File No: LDA11-0376

RE: Tentative plan of subdivision to create three (3) multi family residential lots, and one (1) commercial lot from Lot 1, Block, 90 Plan 0722548 and a portion of Lot 2, Block 90, Plan 1121554 for the consolidation with Lot 1-6 Block 20, Plan 0729861, located east of Rabbit Hill Road and north of Anthony Henday Drive; **MACTAGGART**

## SUBDIVISION CONDITIONS OF APPROVAL MAP

February 7, 2013

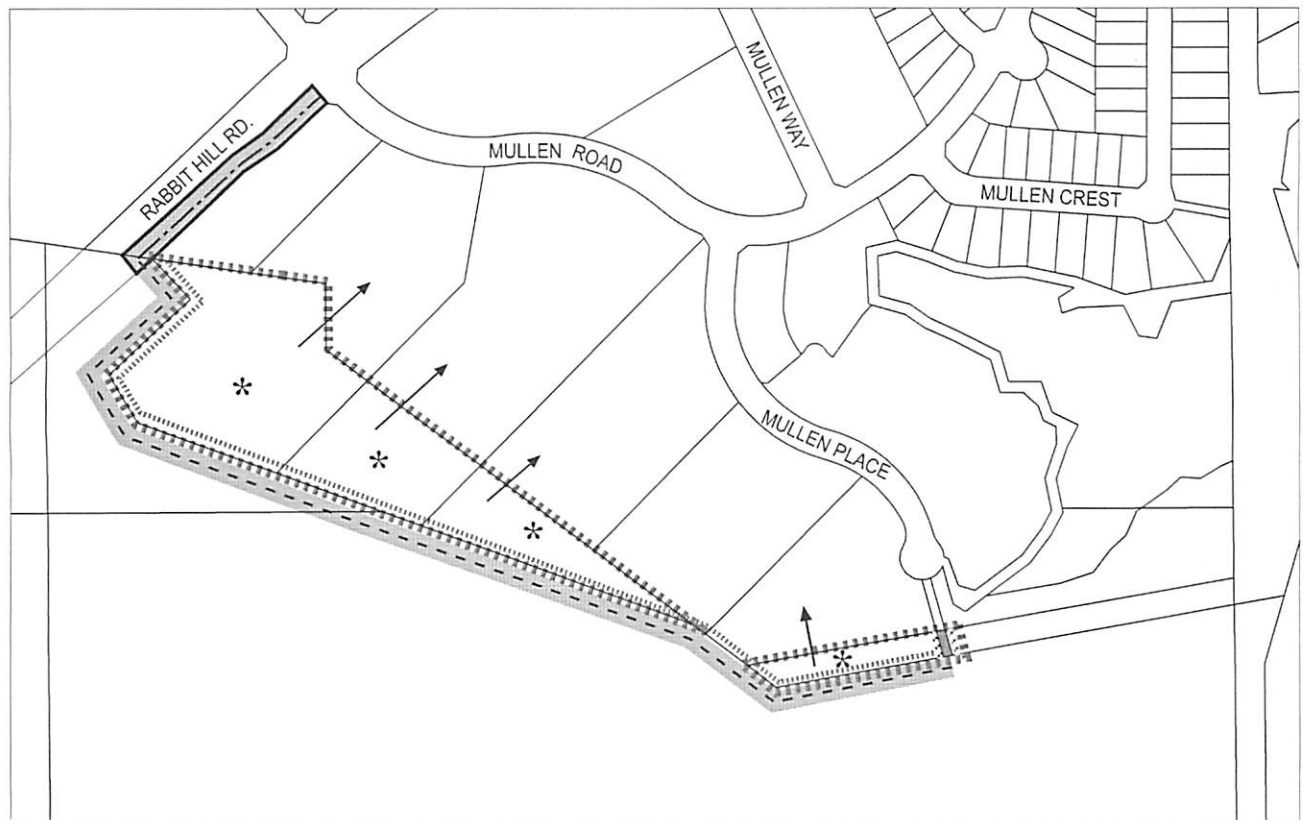
4. that the owner dedicate road right-of-way to conform to a new approved Concept Plan, based on the January 2012, 170<sup>th</sup> Street Planning Study, or to the satisfaction of Transportation Services, for Rabbit Hill Road from the Transportation Utility Corridor (TUC) boundary to Mullen Road SW, as shown on the "Conditions of Approval" map, Enclosure I;

5. that the owner register the walkway as legal road right-of-way, as shown on the "Condition of Approval" map, Enclosure I;
6. that the owner prepare a restrictive covenant in favour of EPCOR Water that will be registered against all lots within this subdivision as shown on the "Conditions of Approval" map, Enclosure I, to identify the requirement for service line pressure reducing valves;

7. that the proposed lots be consolidated with adjacent lots as shown on the "Conditions of Approval" map, Enclosure I; and

7. that the Engineering Drawing include the construction of a 3 m granular shared use path (SUP) within the Transportation Utility Corridor (TUC) and extend the SUP in a northeasterly direction to the Rabbit Hill Road/Mullen Road intersection, as shown on the "Conditions of Approval" map, Enclosure I. Application for Ministerial Consent is to be made by the developer and is required for all development within the TUC;

8. that the owner construct a 1.8 m double board/no gap solid uniform screen fence or combination thereof on a 1 m berm within private property lines for all lots backing or flanking onto the TUC, as shown on the "Conditions of Approval" map, Enclosure I, as per the submitted noise survey for the area. The fence shall be constructed using a low maintenance material with a minimum density of 20 kg/m<sup>3</sup> to the satisfaction of the Transportation Department;

9. that the walkway contain a 1.5 m concrete sidewalk with bollards, lighting, and fence within residential property lines as shown on the "Conditions of Approval" map, Enclosure I; and
